Appendix I of RNTPC  
Paper No. A/YL-LFS/504

**Temporary Open Storage of Construction Materials for a Period of 3 Years**  
**at**  
**Lots 2090 (Part), 2091 (Part) & 2092 (Part) in D.D. 129, Lau Fau Shan, Yuen Long, N.T.**

**Annex 1 Drainage Assessment**

Figure 3

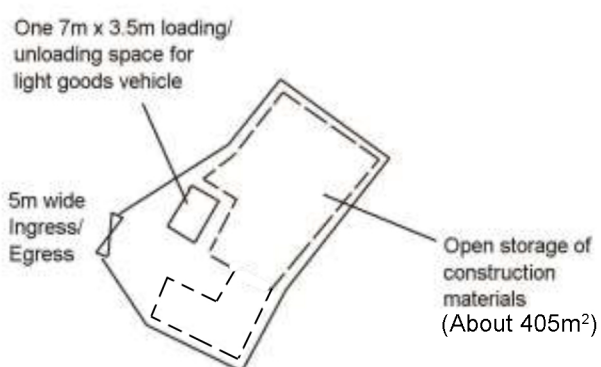
We are glad to submit the updated layout plan for your follow up action. The area for open storage activity is about 405m<sup>2</sup>.
